UNITED STATES PATENT AND TRADEMARK OFFICE

Office Action Summary	Application No. 10/562,382	Applicant(s) FILHO ET AL.	
	Examiner MATTHEW W. ING	Art Unit 3637

DETAILED ACTION

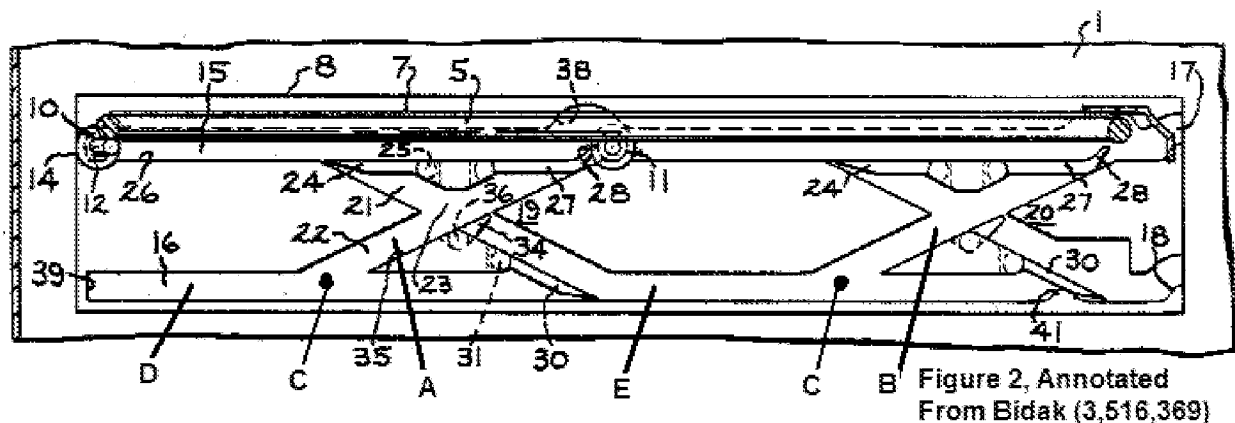
16. Regarding claim 1, Bidak teaches a retractable shelf (4) for the cabinet of a refrigeration appliance, said shelf having each lateral edge (5, 6) slidingly mounted, by two longitudinally spaced apart seating regions (10, 11), on respective rail portions (A & D, and B & E in Fig. 2 Annotated) affixed to opposite internal lateral walls (1) of the cabinet (2), in order to be selectively displaced between at least one lower operative position (i.e., when 10 & 11 are located at points C) and one transitional intermediary position (Fig. 3), in which it is upwardly forwardly displaced, and also between said transitional operative position and an upper operative position (i.e., when 10 & 11 are located at points K), in which it is backwardly displaced, situated above and vertically spaced from the lower operative position.

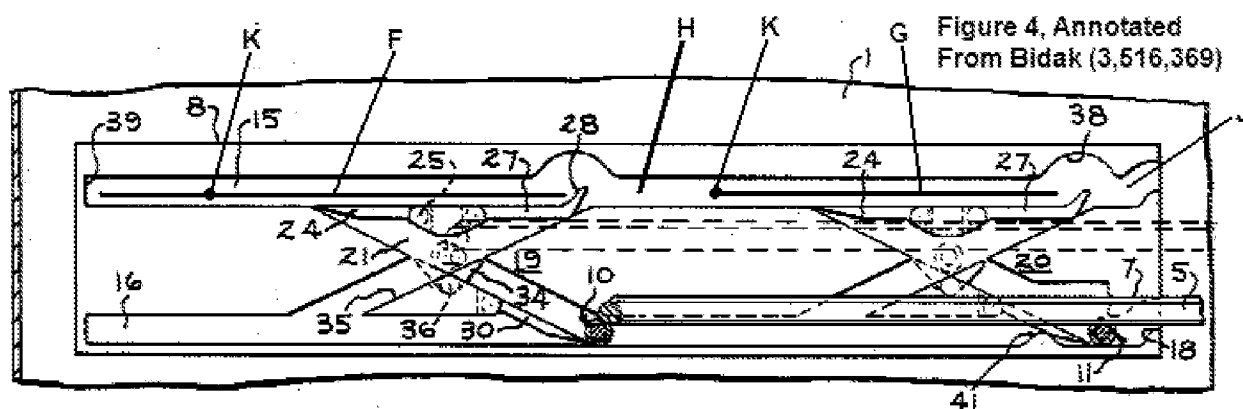
17. Regarding claim 2, Bidak teaches a retractable shelf the transitional intermediary position (Fig. 3) is substantially in the same level of the upper operative position (i.e., when 10 & 11 are located at points K).

18. Regarding claim 3, Bidak teaches a retractable shelf wherein lower and upper operative positions are parallel and vertically aligned to each other. See Figs. 2 & 4 Annotated.

19. Regarding claim 4, Bidak teaches a retractable shelf wherein each rail portion (A & D and B & E) comprises: a lower rail extension (A, B) forwardly upwardly inclined and which presents a closed lower end (D, E) defining the seating position for a respective seating region (10, 11) when the shelf (4) is in the lower operative position, and an open upper end (i.e., upper end of A & B, when 27 is open); and an upper rail extension (F, G) having a rear end defining the seating position for a respective seating region (10, 11) when the shelf (4) is in the upper operative position, and a front end (33b) which is opened (i.e., when 27 is at least partially opened, as in Fig. 3) to the interior of the upper end of the lower rail extension (A, B). The examiner submits that whereas Item E is "closed" at least when Items 30 & 19 are in the positions shown in Fig. 2, Item E can therefore be termed a "closed lower end"; and that whereas A & B are open when Item 27 is open, each of Items A & B can therefore be said to possess an "open upper end". As such, Bidak is viewed as reading upon the limitations of claim 4.
